Planning App Ref:	PL/2025/08543
Service Ref:	Drainage
Date:	02/02/2026

PROPOSAL

Approval of Reserved Matters (internal access, appearance, landscaping, layout and scale) following Outline Planning Permission PL/2022/09532 for 25 dwellings with access to Romsey Road, parking, open space, landscaping, and drainage and approval for pursuant to conditions 10, 20 and 22 of PL/2022/09532

Land at Romsey Road, Whiteparish, Salisbury, Wiltshire

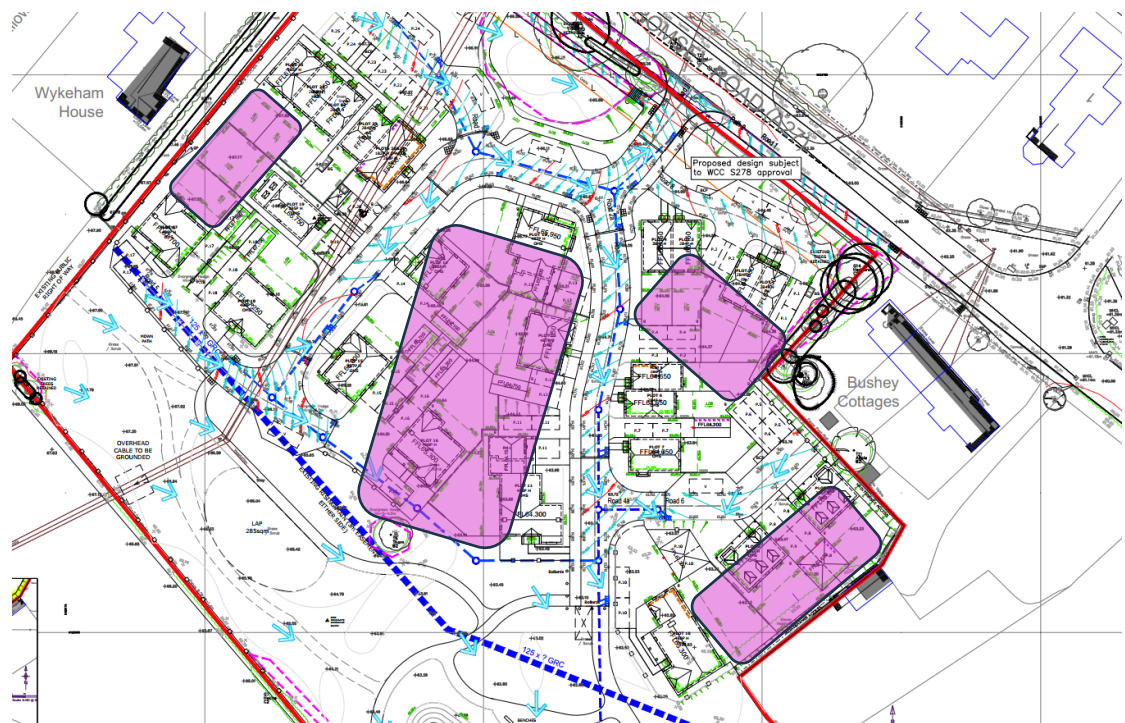
- While noting the applicant has provided a revised exceedance flow path drawing, further details are required.

Currently, it is not clear whether retaining walls will block surface water flows, or where surface water may pool. For example, it is unclear where water will pool adjacent to plots 17-21, and the exceedance arrows do not entirely match the CAD flow arrows beneath – notably by spot level 67.08 and 67.17.

The applicant must add hatching to the drawing where pooling will occur onsite during the 1 in 100+CC event, and outline whether each retaining wall will block flows, or allow flow to pass through (e.g. plot 11 & 16).

This information is required to comply with the National Standards for SuDS ([Standard 3: management of extreme rainfall and flooding](#))
